SUBJECT: CLINTON POWER STATION DRAFT SER SUPPLEMENT # 5

DRAFT

Supplement No. 5 to the Safety Evaluation Report on the application filed by Illinois Power Company, Soyland Power Cooperative, Inc., and Western Illinois Power Cooperative, Inc. as applicants and owners, for a license to operate the Clinton Power Station, Unit No. 1, has been prepared by the Office of Nuclear Reactor Regulation of the U.S. Nuclear Regulatory Commission. The facility is located in Harp Township, DeWitt County, Illinois. This supplement reports the status of items that have been resolved by the staff since Supplement No. 4 was issued.

Figure 13.1 Management and technical support organization for Clinton
power station (revised from SER)

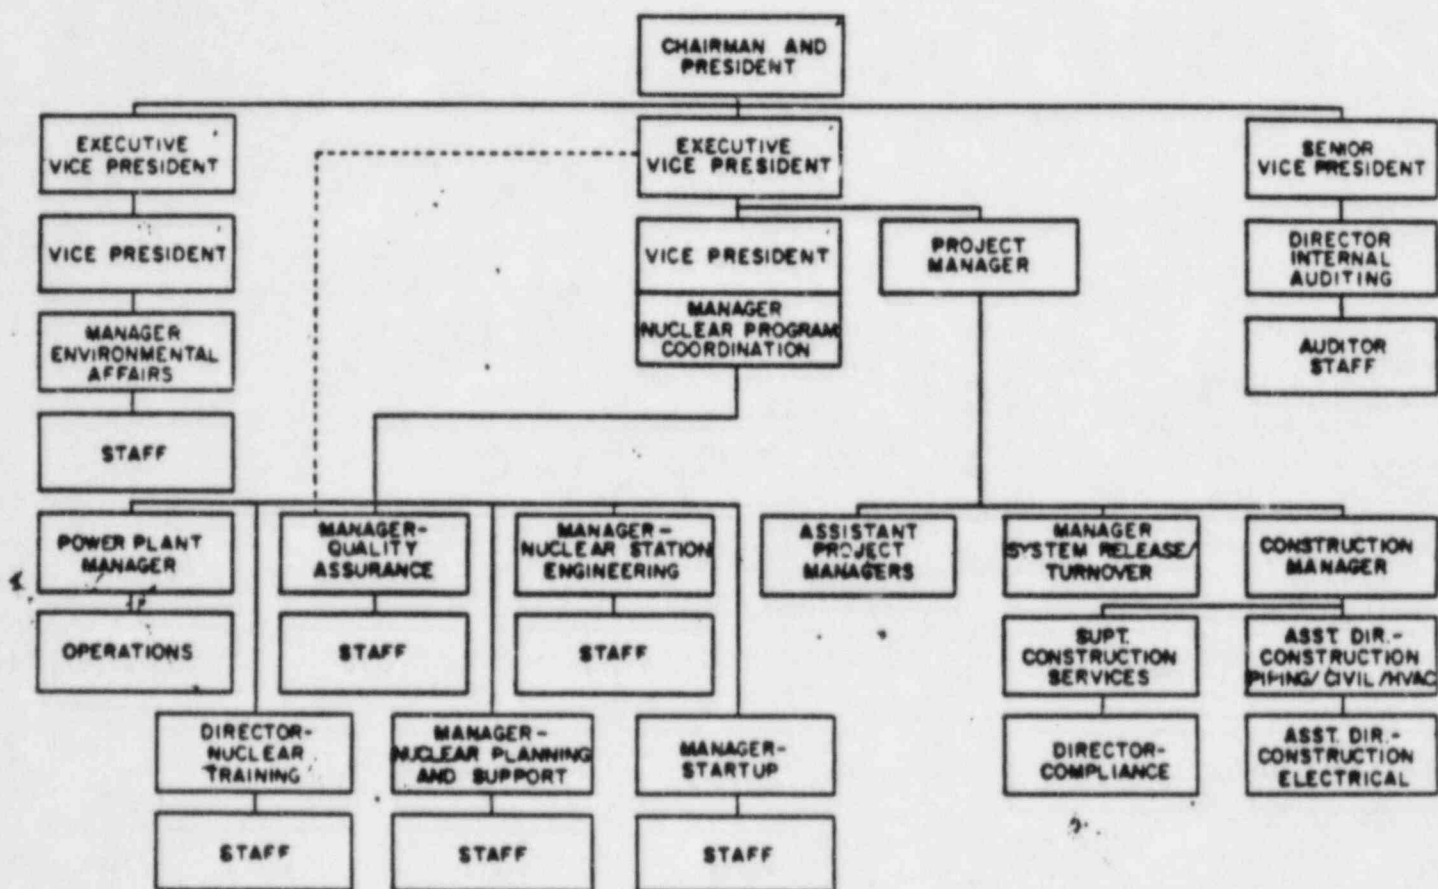
The corporate organization and lines of responsibility for management and technical support of Clinton are shown on revised Figure 13.1 of this supplement. The basic difference affecting Clinton between this support organization and the one accepted in the Clinton SER is the addition of three departments under the Vice President responsible for nuclear projects. A brief description of the new departments is provided below.

Figure 13.3 Plant organization for Clinton Power Station (revised from SER)

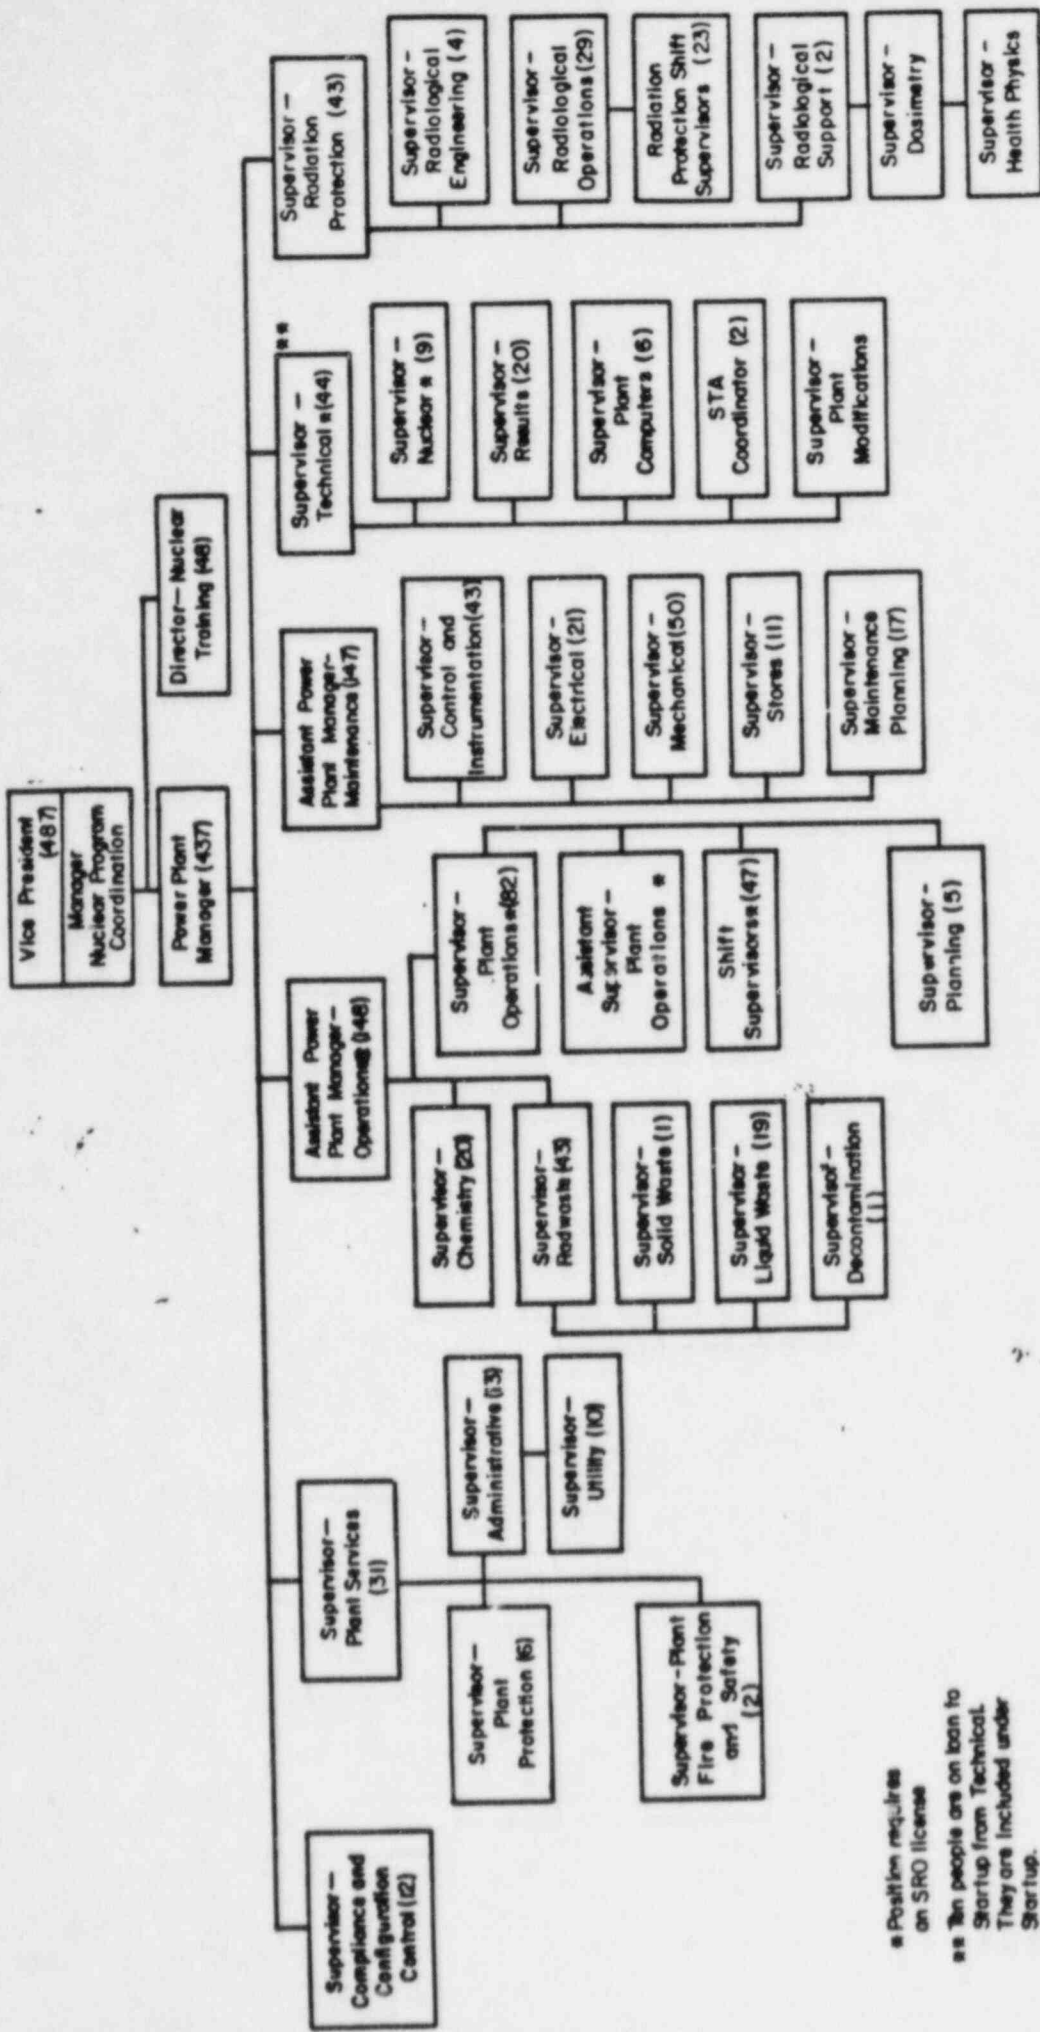
The organization of Clinton is shown on revised Figure 13.3 of this supplement. The applicant has modified the Clinton organization from that originally reviewed and reported in the SER, NUREG-0853. The most significant change is the establishment of a separate organization for radiation protection. A brief description of the radiation protection group responsibilities follows.

The Radiation Protection Department is responsible for the planning and development of the operational aspects of radiation protection and radiological monitoring at Clinton. The Supervisor of Radiation Protection reports to the Plant Manager of Clinton.

The applicant's current plant organization was reviewed against criteria expressed in the SRP and was judged acceptable.
